Author: [REDACTED]
Project Number: 65208801-001
Project Name: Capital Programme
Client : IHE
Project Manager: [REDACTED]

Affordable Housing and Drainage

1. North and West

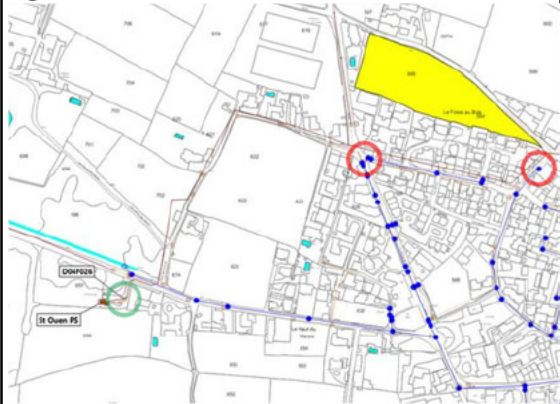
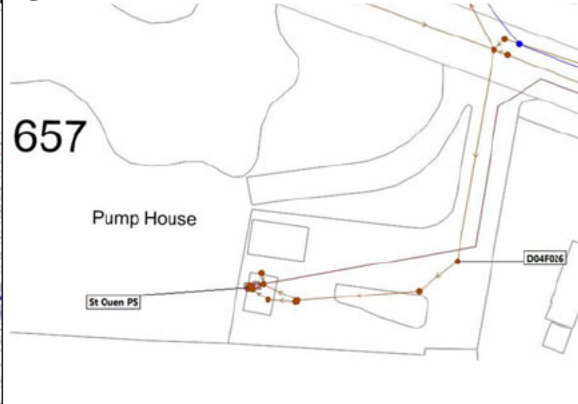
2.1	<p>St Ouen O594/595 Sweco to provide detail of alternate foul connection point for inclusion in the Guidance Pack [Post Meeting Note: Fig 1 to 3 below]. The requirements for attenuation of surface water will only be refined as hard areas (roof, road etc) are confirmed.</p> <p>O785 No issues</p>	<p>Sweco [REDACTED]</p>	yes

<p>Fig 1</p> 	<p>Fig 2</p> 
	<p>Fig 3</p> 	<ul style="list-style-type: none"> • Fields O594/595 shown in yellow. • Cannot connect at the obvious points in the network (red circles) without causing flooding. • Connection immediately upstream of St Ouen PS is okay – Manhole D04F026. • Route is indicative and assumes agreement can be reached with landowner and/or highways. • Route is approx. 500m long which may be more than a developer would like to take on. • Gravity connection should work (detailed design required but works for the existing flow from the red circles) and will allow other development along the route to connect. • BUT – it may be easier to install a small pumping station within the site. The rising main would be a smaller diameter than the gravity pipe.
